Access Compliance Report

Public Rights-of-Way

Intersection ID: 48569	Main Street: RED_SQUIRREL_TL	Cross Street: SALAMANDER_RUN_LN	Location: SE
ADA ID: 73BC8BC927AA	Ramp Type: BlendTrans1	Initial Pass/Fail: Pass	Overall Compliance: No
Severity Score: 0			
Codes/Mitigation Info/Possible Solution		Field Measurements/Component Compliance

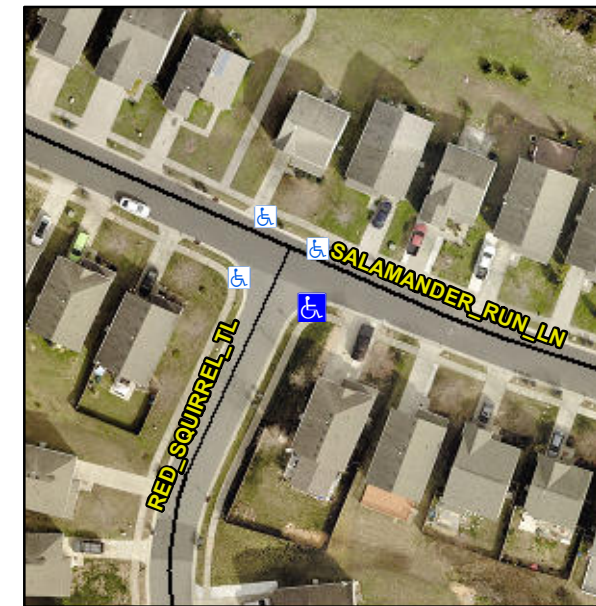
Not Found, R304.2.1

N/A	Ramp inside XWalk1?	N/A	N/A	Ramp inside XWalk2?	N/A
	Road Slope (%)	1.4		Clear Space?	Yes
	Road X Slope (%)	1.4	N/A	Clear Space to XWalk (in)	N/A
Yes	Any Obstructions?	No	Yes	Storm Grate/Utility Hazard?	No
	Obstruction Type			Storm Grate/Utility Type	
		N/A			N/A
			Yes	Surface Condition? (G/P)	Good
			No	Curb Slope (%)	18.3

Remove & Replace Curb Ramp With Two New Directional Ramps or Equivalent.
